To
J. F. OikDate
January 28, 1976From
J. C. DevittSubject
FARO DEPOSIT MARGINAL DRILLING PROGRAM

Subject FARD DEPOSIT MARGINAL DRILLING PROGRAM
RE: MEMO FROM D. S. JENNINGS DATED DECEMBER 4, 1975
RE: MEMO FROM J. F. OLK DATED JANUARY 16, 1976

Subject Faro Deposit Marginal Drilling Program
Memo from D. S. Jennings dated December 4, 1975

Faro Deposit Marginal Drilling Program

FIGURE 1
 DRILL HOLE SPACINGS
 1" = 100'

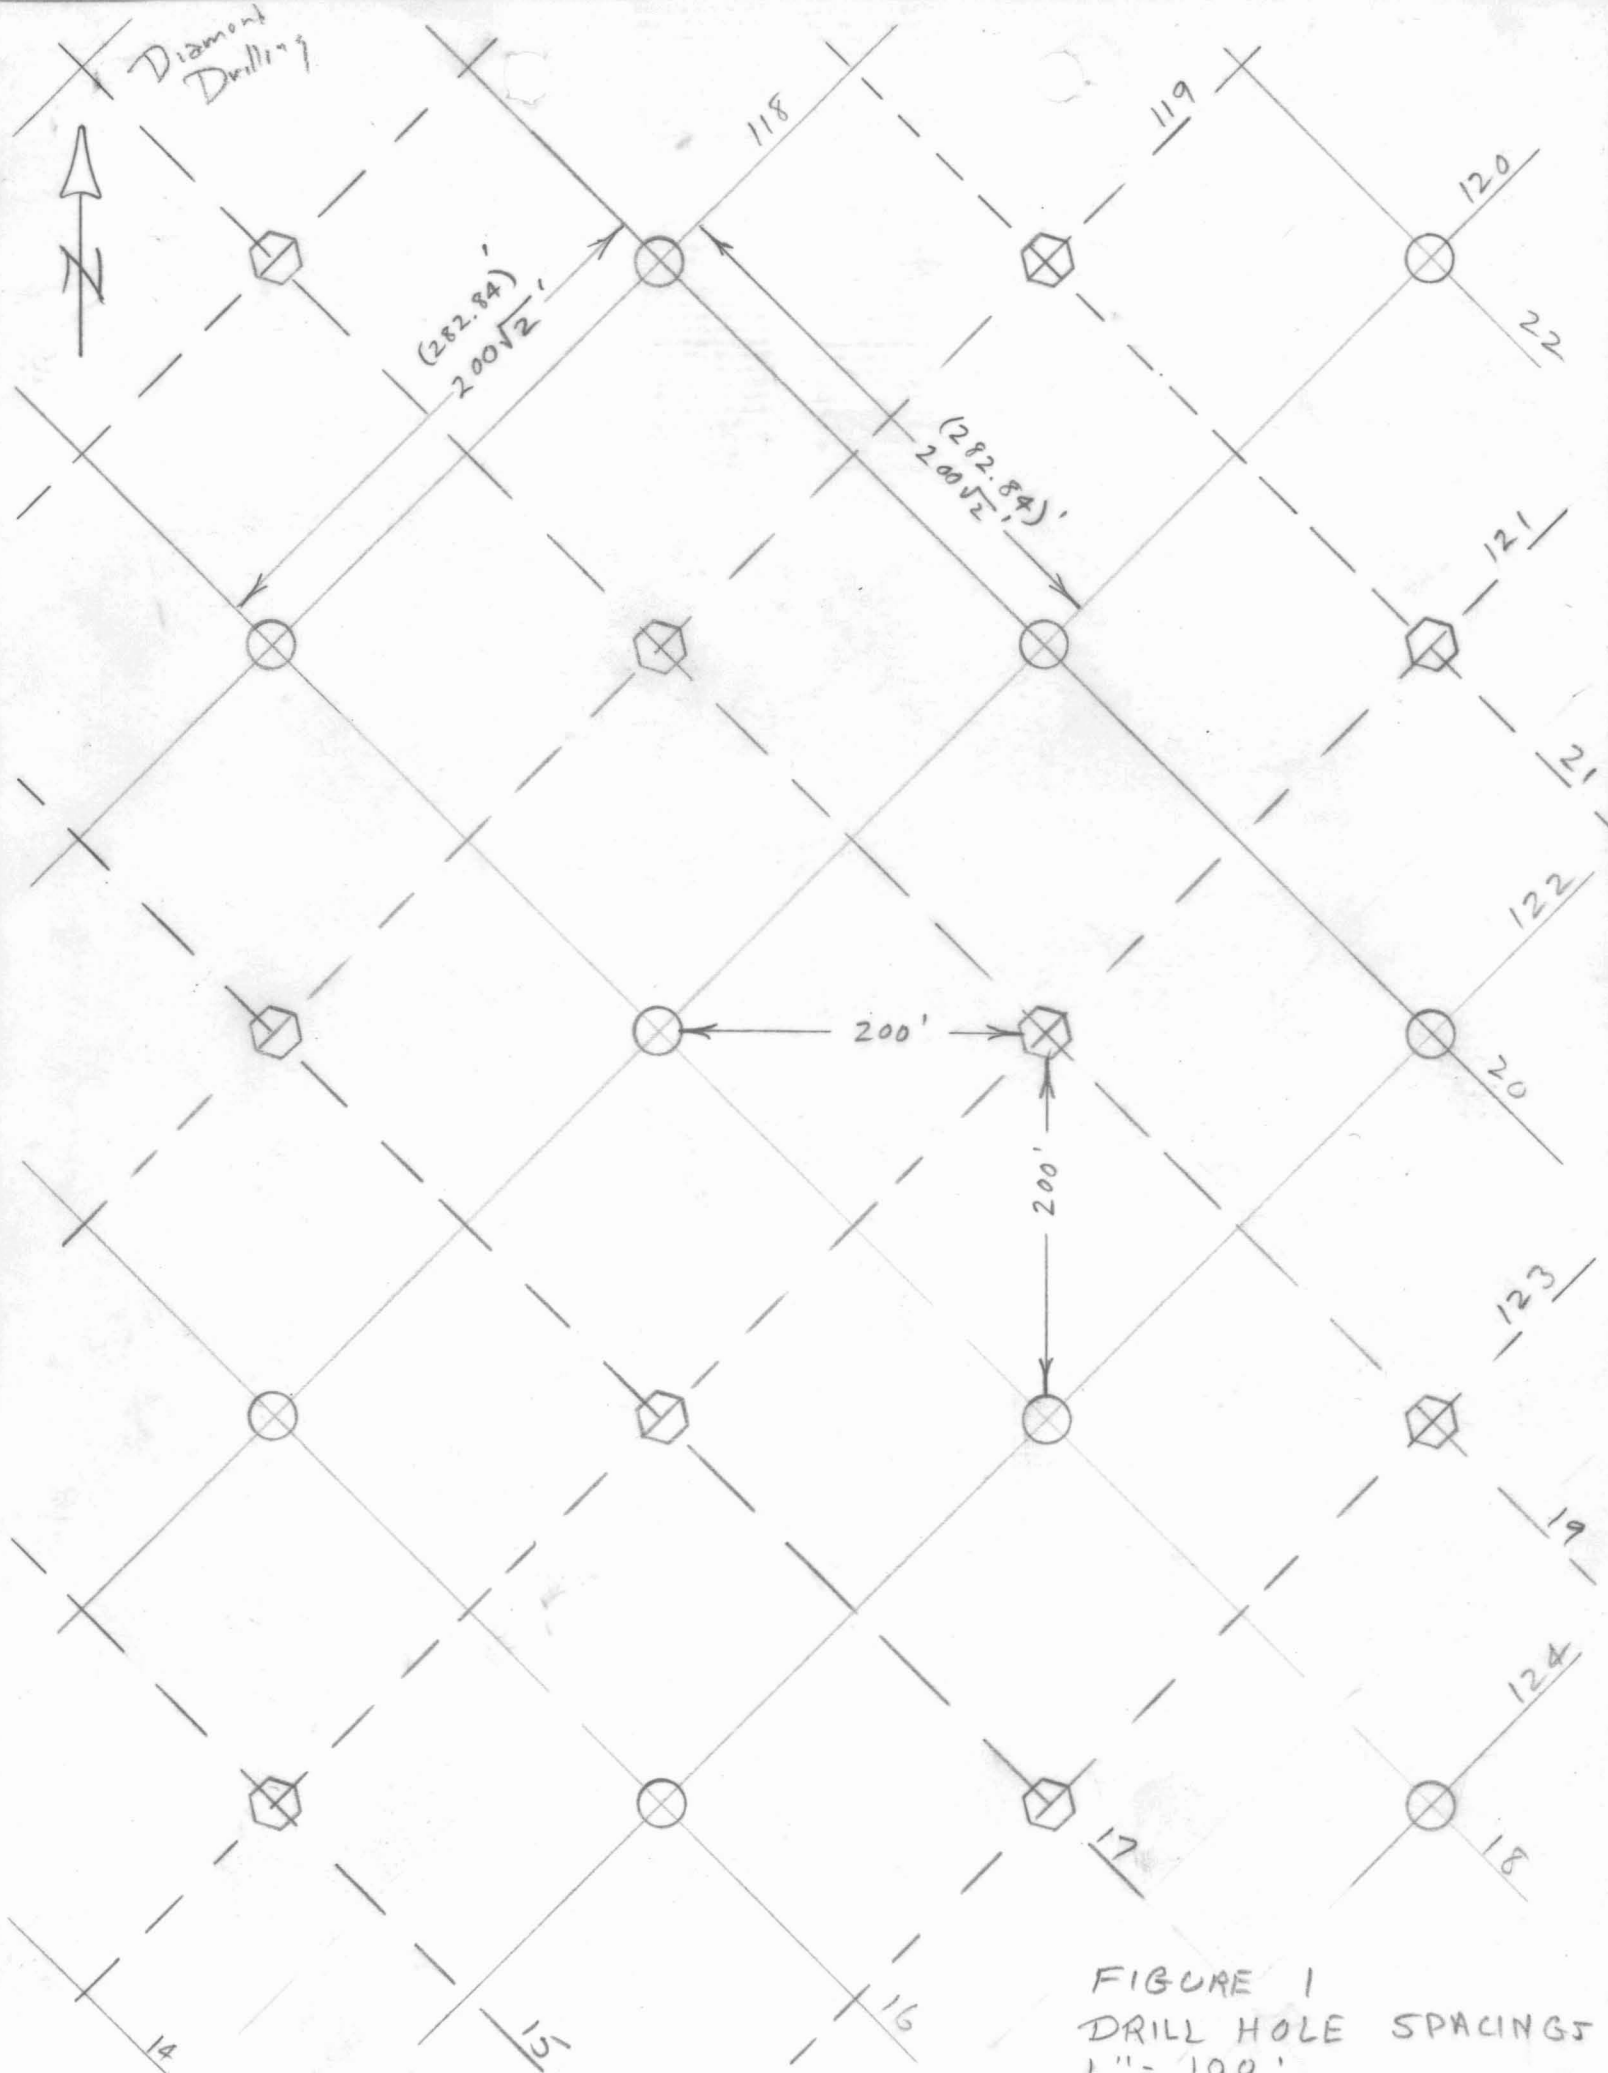
Drill holes were originally laid out on a grid oriented 45° from north on $200\sqrt{2}$ (282.84) ft. centers. (See Fig. 1 attached). Mining in Zone 1 during the first couple of years showed the spacing to be inadequate, as projected ore tonnages in many cases failed to materialize during mining. More drilling was done at the intersection of odd-numbered sections between the original even-numbered section intersections, but only covering material to be mined a year or so in advance. From this closer spaced drilling (200 x 200' pattern), many differences from the original orebody projection became evident. Internal pyritic waste and a previously undetected diorite dike cutting through the center of the orebody were identified. In some cases the addition of previously undetected ore to
